KOKU-KU-KI-267

No. TCD-8201C-1-2022

Japan Civil Aviation Bureau
TAIKUSEI-KAIZEN-TSUHO
Airworthiness Directive

1. Applies to: Kawasaki BK117 series helicopters equipped with a Goodrich rescue hoist assembly having a Part Number (P/N) as listed in Table 2.1 of this AD.

Figure 1

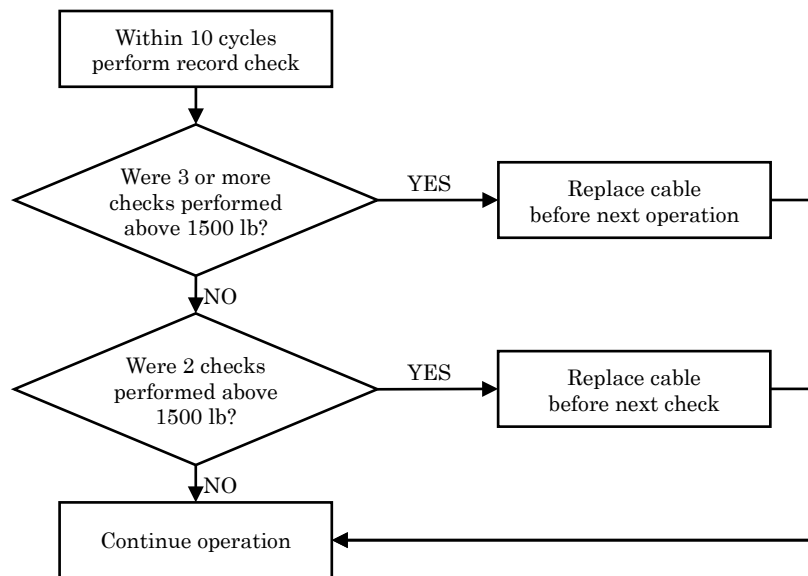
2.1 Within 10 hoist operating cycles from June 17, 2016 (the effective date of AD No. TCD-8201C-2016), accomplish a records check to determine whether, during any previous hoist load check/test, a cable was load-tested (average of 5 pulls) at 1500 lb [680 kg] or more. If any cable is identified to have exceeded this limit during two or more hoist load checks/tests, replace the affected cable with a serviceable cable within the time interval shown in paragraph 2.1.1 or 2.1.2 of this AD. For replacement of a cable, see Figure 1 of this AD.

2.1.1 If any cable is identified to have exceeded this limit during three or more hoist load checks/tests, before next hoist operation.

2.1.2 If any cable is identified to have exceeded this limit during two hoist load checks/tests, before the next hoist load check/test.
